SUBMITTAL OF HANFORD FACILITY RESOURCE CONSERVATION AND RECOVERY
ACT (RCRA) PERMIT MODIFICATION NOTIFICATION FORM 24590-HLW-PCN-ENV-
07-001

Hanford Facility RCRA Permit Modification Notification
Form 24590-HLW-PCN-ENV-07-001

Page 2 of 4: Hanford Facility RCRA Permit, Operating Unit 10, Waste Treatment and Immobilization Plant
Update HLW Plant Item Mechanical Data Sheets for the High-Level Waste Facility Activated Carbon
Adsorbers (HOP-ADBR-00001A/B and HOP-ADBR-00002A/B) in Appendix 10.6 of the Dangerous Waste
Permit.

MECHANICAL DATA SHEET ACTIVATED CARBON ADSORBER

24590-HLW-MVD-HOP-00015

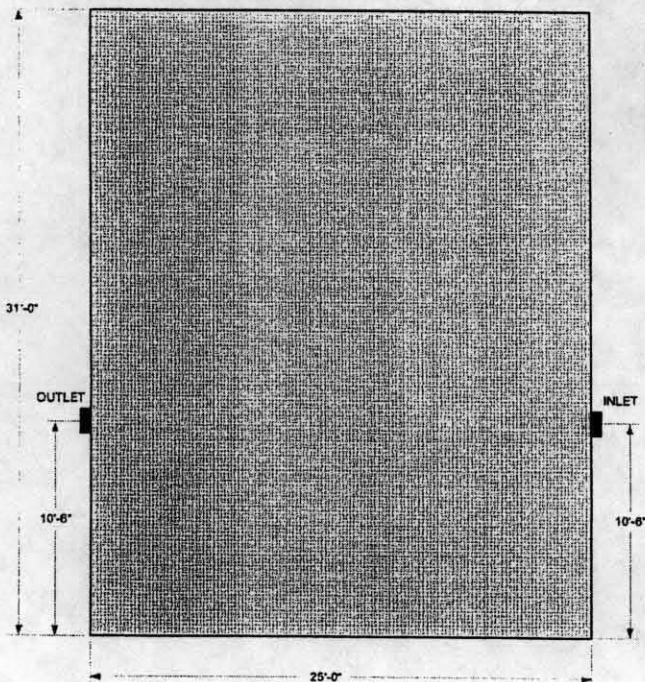
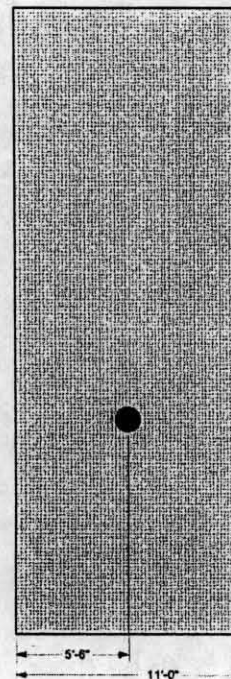
Hanford Facility RCRA Permit Modification Notification Form	
Unit: Waste Treatment and Immobilization Plant	Permit Part & Chapter: Part III, Operating Unit 10
<p><u>Description of Modification:</u></p> <p>The purpose of this modification is to update HLW Plant Item Mechanical Data Sheets for the High-Level Waste Facility Activated Carbon Adsorbers (HOP-ADBR-00001A/B and HOP-ADBR-00002A/B) in Appendix 10.6 of the Dangerous Waste Permit. The following source mechanical data sheets are submitted to replace the permit data sheets currently in Appendix 10.6:</p> <ul style="list-style-type: none"> Mechanical Data Sheet Activated Carbon Adsorber (24590-HLW-MVD-HOP-00015, Rev 1) Mechanical Data Sheet Activated Carbon Adsorber (24590-HLW-MVD-HOP-00016, Rev 1) <p>The above mentioned mechanical data sheets include revisions as indicated by revision triangles shown on the documents. The revisions shown are the result of ongoing design (changes from vendor preliminary data to vendor detailed design). The following are the sections affected by changes to the above mentioned mechanical data sheets:</p> <ul style="list-style-type: none"> Incorporation of Environmental Qualification information (New Section) Incorporation of Code 1 vendor submittal information <ul style="list-style-type: none"> Thermal Information <ul style="list-style-type: none"> Revised maximum heat loss from 0.5 Kw (per unit) to 5 Kw (per unit) Activated Carbon Data <ul style="list-style-type: none"> Revised the type of carbon for the guard bed from Desomix G-10 to Desomix ZA-37 Revised the activation element from sulfur to sulfur compounds for the primary bed and from powdered coke & hydrated lime to unimpregnated activated charcoal for the guard bed Revised the carbon media form from spheres to granular for the guard bed Bulk density is revised from 0.48 g/cc (30 lbs/ft³) to 0.57 g/cc (36 lbs/ft³) for the primary bed and from 0.85 g/cc to 0.57 g/cc (36 lbs/ft³) for the guard bed Residence time is revised from 2.9 to 6 (at design flow rate in SCFM) for the primary bed and from 1.45 to 3 (at design flow rate in SCFM) for the guard bed Total volume of carbon has been clarified to be per vessel and is revised from 200 ft³ to 220 ft³ for the primary bed and from 100 ft³ to 110 ft³ for the guard bed Total weight of carbon has been clarified to be per vessel and is revised from 6590 lbs to 7920 lbs for the primary bed and from 5600 lbs to 3960 lbs for the guard bed The face velocity through the carbon is revised from 34.5 fpm to 16.67 fpm (at design flow rate in SCFM) for both the primary bed and guard bed House/Vessel <ul style="list-style-type: none"> Revised the material/thickness from 1/4 inch to 3/8 inch Vessel dimensions are revised from 132.5"x96.5"x156" to 138"x112"x156" Revised the total weight of the vessel from an estimated 15,000 lbs to an estimated 22,670 lbs per vessel Revised the weight of the vessel with carbon from 28,000 lbs to 34,550 lbs Design pressure is revised from -80 in-WG to -82 in-WG and added a positive design pressure of 126 in-WG Revised the operating pressure from -51 in-WG to -18.1 in-WG Design temperature is revised from 275 F to 250 F Revised the housing insulation material thickness from 4-6 inches to 7 inches on sides,

- 1 inch over stiffeners
 - Revised the unloading on/off valve from 4 to 8 per vessel and from 4 inch to 8 inch size
- Discharge Filter
 - Filter material is revised from microglass fibers to microglass paper

- Clarified filter frame material is type 316
 - Revised dimensions of filter from 24" x 24" x 4" to 23 3/8" x 23 3/8" x 3 3/4"
 - Revised the weight of the filter from 10 lbs to 15 lbs

- Revised the maximum allowable temperature from 300 F to 250 F
- Connecting Pipe
 - Revised the material/thickness from 0.188 inches to 0.25 inches
 - The total length of piping is revised from 50 ft to 70 ft

- The weight of the valve is revised from 150 lbs to 143 lbs
 - Revised the valve manufacturer from Ionex to Centerline Valves
 - Removed the option of using electric actuators

- Revised actuator manufacturer from Rotech to Hi-Tork
 - The minimum actuator operating pressure changed from 100 to 80
 - Revised the opening time from less than 5 seconds to less than 10 seconds

- The required instrument air supply is revised from less than 1 to 2 SCFM per actuator
 - The recommended piping insulation material thickness is revised from 4-6 inches to 1 inch

- Construction Data
 - Operating weight of the unit (2 vessels) is revised from 56,000 lbs to 69,100 lbs
 - Full water flood weight of unit (2 vessels) is revised from 89,000 lbs to 114,100 lbs

- Shipping weight is revised from 56,000 lbs to 71,500 lbs

Appendix 10.6					
Replace:	24590-HLW-MVD-HOP-P0015, Rev. 0	With:	24590-HLW-MVD-HOP-00015, Rev. 1		
Replace:	24590-HLW-MVD-HOP-P0016, Rev. 0	With:	24590-HLW-MVD-HOP-00016, Rev. 1		
WAC 173-303-830 Modification Class: ^{1 2}		Class 1	Class ¹ 1	Class 2	Class 3
Please mark the Modification Class:			X		
Enter Relevant WAC 173-303-830, Appendix I Modification citation number:		N/A			
Enter wording of WAC 173-303-830, Appendix I Modification citation:					
In accordance with WAC 173-303-830(4)(d)(i), this modification notification is requested to be reviewed and approved as a Class ¹ 1 modification. WAC 173-303-830(4)(d)(ii)(A) states, "Class 1 modifications apply to minor changes that keep the permit current with routine changes to facility or its operation. These changes do not substantially alter the permit conditions or reduce the capacity of the facility to protect human health or the environment. In the case of Class 1 modifications, the director may require prior approval."
